Subject: AP1000 COL Standard Technical Report Submittal of APP-GW-GLN-079, (TR 79),
Revision 1

“Electrical System Design Changes”

AP1000 DOCUMENT NO. APP-GW-GLN-079	REVISION NO. 1	Page 1 of 41	ASSIGNED TO W- A. Sterdis
---------------------------------------	-------------------	--------------	------------------------------

TITLE: **Electrical System Design Changes**

Figure 2.6.1-1 (Sheet 1 of 4)
 Main ac Power System

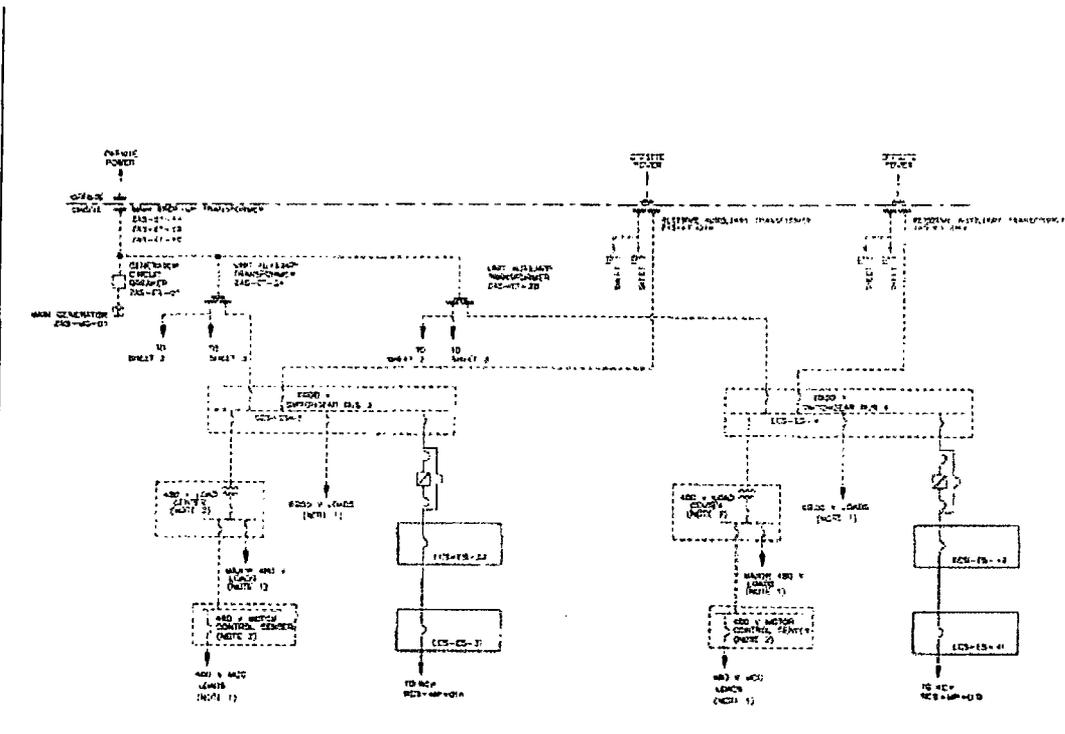
The addition of a fast bus transfer, along with an operator initiated maintenance transfer was made to the AP1000. This change required an additional Reserve Auxiliary Transformer (RAT) to allow complete bus transfer from Unit Auxiliary Transformers to Reserve Auxiliary Transformers. DCD figures 8.3.1-1 and 2.6.1-1 will be revised along with several portions of the DCD text.

Figure 2.6.1-1 (Sheet 3 of 4)
Main ac Power System

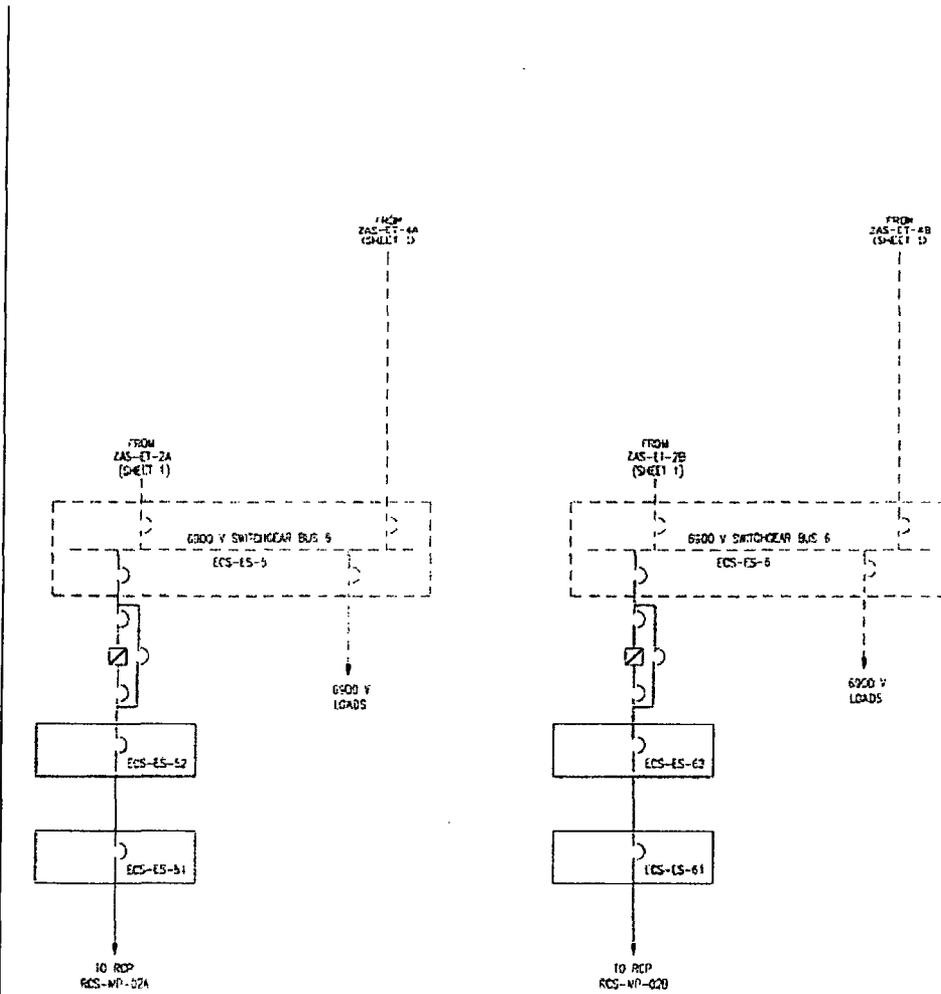
Item: Input and output isolation breakers to each RCP variable frequency drive unit were added (pages 8.3-53, 2.6.1-11, and 2.6.1-13).

Figure 3.8.2-4 (Sheet 6 of 6)

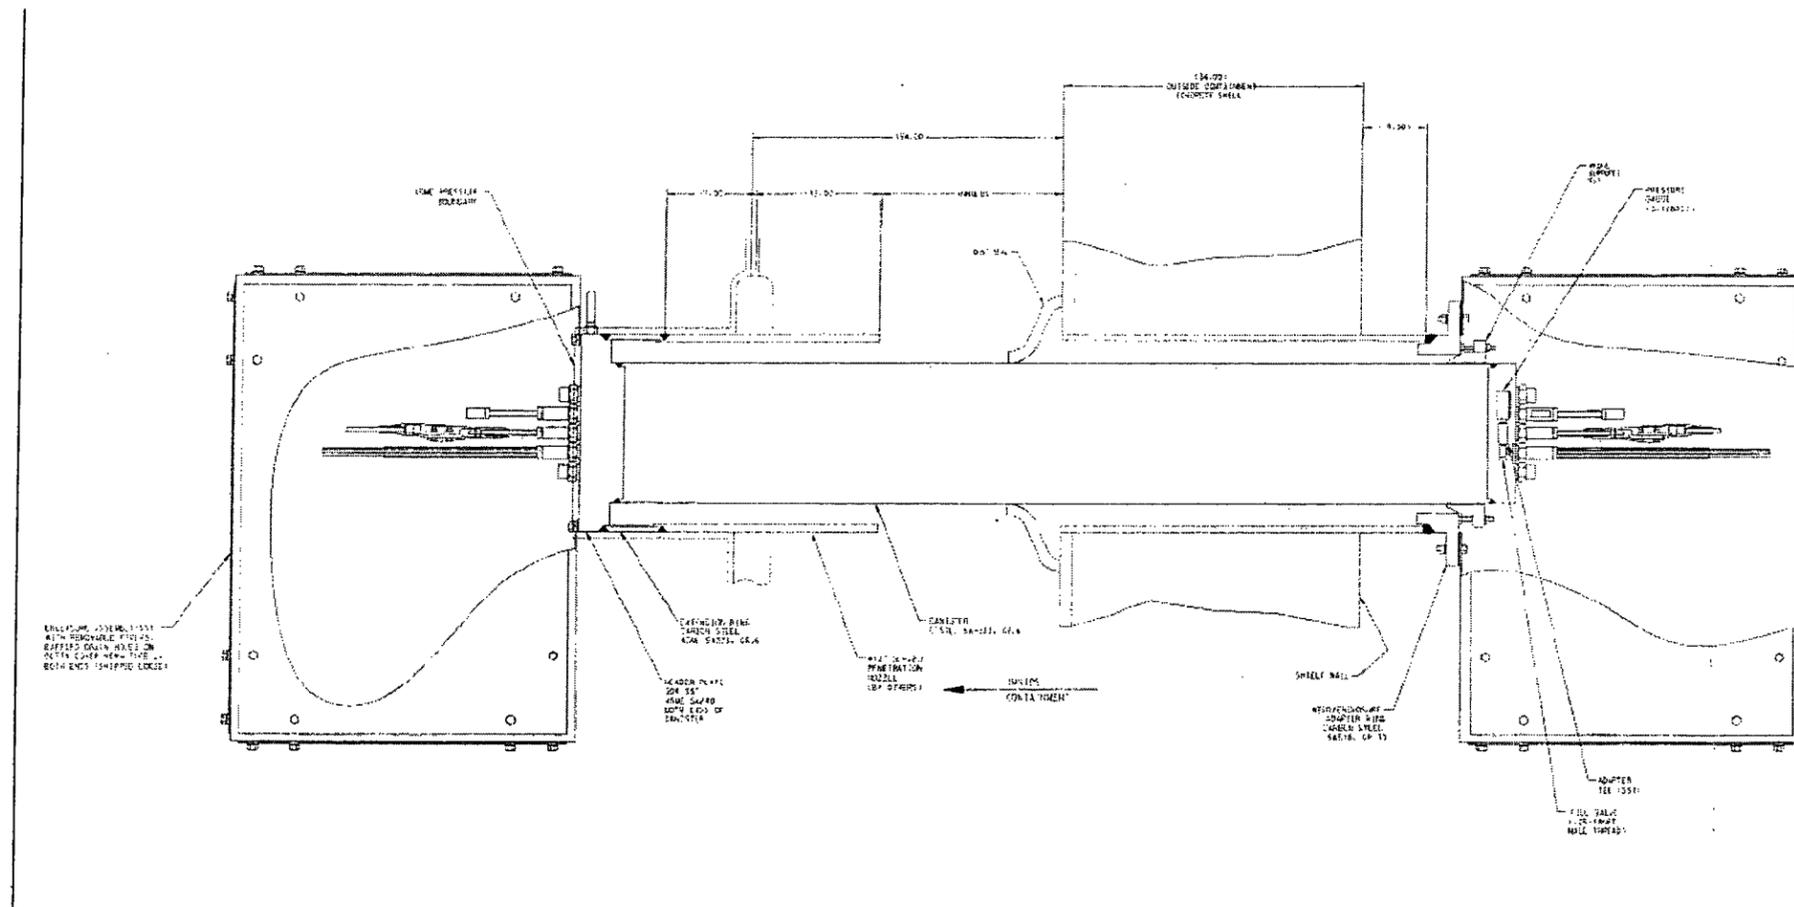
The current design utilizes an epoxy construction type of electrical penetration. During design development, the recommendation has been made to revise current electrical penetration description to allow either an epoxy construction type of electrical penetration or a swaged construction type of electrical penetration

Additionally, a change from a welded connection to a supporting edge with a tapered leading edge and threaded rod to permit concentric alignment of the Electrical Penetration Assembly canister in the nozzle was made.

The current design utilizes an epoxy construction type of electrical penetration. During design development, the recommendation was made to revise current electrical penetration description to allow either an epoxy construction type of electrical penetration or a swaged construction type of electrical penetration.

Additionally, when the Containment Vessel is pressurized, the current configuration of the electrical penetration may not be able to accommodate the radial displacement of the Containment Vessel shell due to the electrical penetration being welded to the fixed enclosure. A change from a welded connection to a supporting edge with a tapered leading edge and threaded rod to permit concentric alignment of the Electrical Penetration Assembly canister in the nozzle is recommended by a penetration manufacturer.

Figure 3.8.2-4 in the DCD was based on the epoxy construction type of electrical penetration. This DCD figure was revised to allow both types of electrical penetrations. Additionally text changes within the DCD were made to allow for penetration types other than epoxy construction type.

Figure 3.8.2-4, sheet 6, shows a typical 12-inch-diameter electrical penetration. The penetration assemblies consist of ~~three conductor~~ modules (or ~~six medium voltage cable~~ modules in a similar 18-inch-diameter penetration) passing through a bulkhead attached to the containment nozzle. Electrical design of these penetrations is described in subsection 8.3.1.1.6~~s~~.

Figure 8.3.1-1

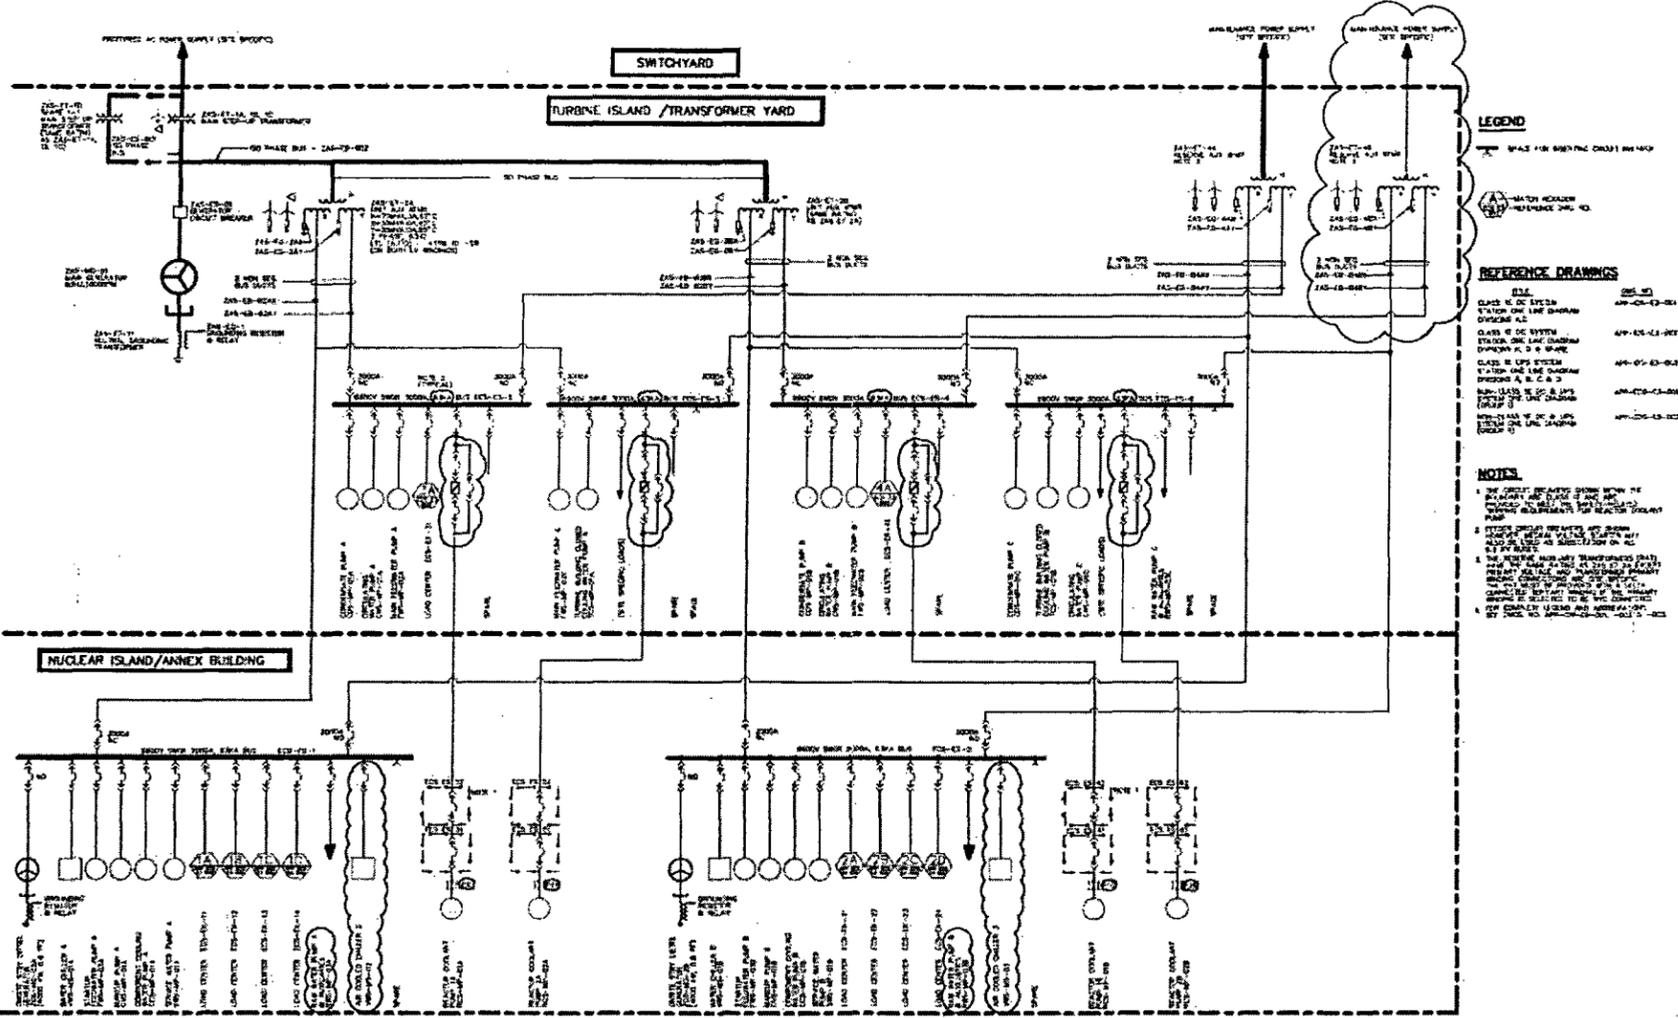
Item: The short circuit rating of the 6.9KV switchgear busses identified on the figure 8.3.1-1 (AC Power Station One Line Diagram) is "500MVA". This value was revised to 63kA. This 63kA value will replace the 500 MVA value directly. This applies to both the DCD one line figure and to the DCD text/ tables (page 8.3-38 and 8.3-53).

Item: The penetration numbers currently shown in Revision 15 on figure 8.3.1-1 are incorrect and were revised to reflect the correct penetrations association with each RCP. This is a documentation change to reflect accurate numbering as developed through the numbering procedure and the latest layout drawing (page 8.3-53).

Item: Figure 8.3.1-1 (plant single line drawing) of the DCD did not show the air cooled chillers VWS-MS-02 and VWS-MS-03 being fed from the 6.9KV busses directly. This is inconsistent with the design for this size motor load and the DCD was revised to reflect these loads being directly connected to the 6.9kV busses. This change is a drawing update (page 8.3-53).

The Revision 15 1-line figure, DCD figure 8.3.1-1 shows 3 feeders for 3 raw water pumps. The change is to have each of these three feeders support the respective raw water pump in addition to the auxiliaries of each pump (page 8.3-53).

Item: The short circuit rating of the 6.9KV switchgear busses identified on the figure 8.3.1-1 (AC Power Station One Line Diagram) is "500MVA" [which loosely translates to 40kA interrupting capacity at 6.9KV]. This value was revised to 63kA. This 63kA value replaces the 500 MVA value directly. The calculated value of short circuit current which represents the DCD defined and calculation supported source equipment sizes (UAT and RAT at 70MVA), and with an impedance value low enough to allow for the starting of the largest pump is well in excess of 50KA (about 58KA conservatively).

Item: The penetration numbers shown in figure 8.3.1-1 of Revision 15 of the DCD were incorrect and were revised to reflect the correct penetrations associated with each RCP. This is a documentation change to reflect accurate numbering as developed through the numbering procedure and the latest layout drawing. The penetration numbers currently shown on the drawing are E9, E10, E25, and E26. As per the AP1000 numbering procedure, the correct penetration numbers are P10, P26, P9, and P25 for each of RCP 1B, 2B, 1A, and 2A respectively.

Item: Figure 8.3.1-1 (plant single line drawing) of the DCD Revision 15 does not show the air cooled chillers VWS-MS-02 and VWS-MS-03 being fed from the 6.9kV busses ES-1 and ES-2 respectively directly. This is inconsistent with the design for this size motor load and the DCD was revised to reflect these loads being directly connected to the 6.9kV busses. This change is a drawing update.

The Revision 15 1-line figure, DCD figure 8.3.1-1 shows three feeders for three raw water pumps. The proposed change is to have each of these three feeders support the respective raw water pump and the associated auxiliaries of that pump.

Figure 8.3.1-3

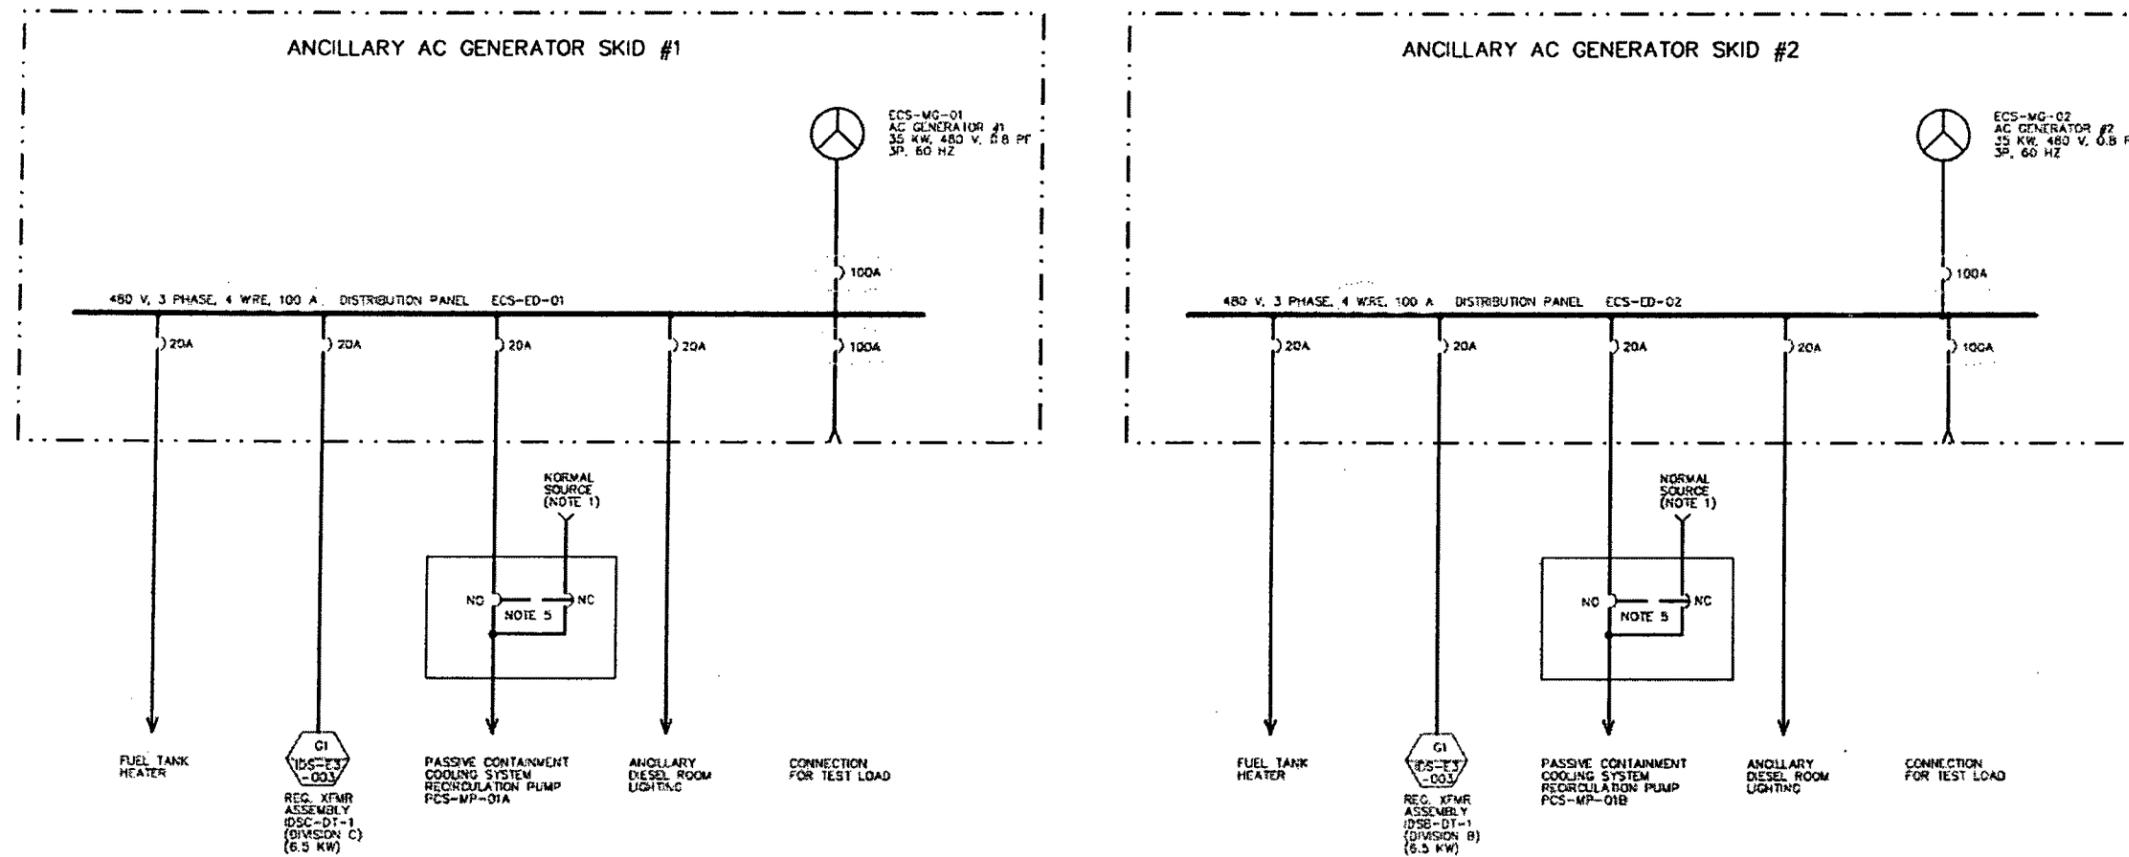
Item: Ancillary diesel 1-line Figure 8.3.1-3 was revised to reflect a 4 wire 100A distribution panel (from a 3-wire 50A), and a 100A breaker for both the diesel generator to the bus and for the test load tie to the bus from 50A (page 8.3-56).

The size of the ancillary diesel generator distribution panels are shown as 50A with an incoming breaker of 30A from the generator. Full load current of this generator is approximately 53A. The main breaker of the distribution panel should be sized at the full capacity of the generator at a minimum. The diesel generator test load will also be changed to 100A to allow for this generator to be tested at full capacity. Additionally, to facilitate the use of this source as a feed to 277Vac lighting circuits, these panels will be changed from 3W to 4W.

A review of industry standard product offering for 480Vac distribution panels shows that the minimum sized standard product is a 100A main breaker, 100A main bus. The rating of these panels will be changed to reflect this 100A rating based on the ready availability of standard product offerings.

Item: Ancillary diesel 1-line Figure 8.3.1-3 was revised to reflect a 4 wire 100A distribution panel (from a 3-wire SOA), and a 100A breaker for both the diesel generator to the bus and for the test load tie to the bus from SO (page 2.3-56).

Figure 8.3.1-3 of Revision 15 was revised to reflect a 4 wire 100A distribution panel, and a 100A breaker for both the diesel generator to the bus and for the test load tie to the bus.
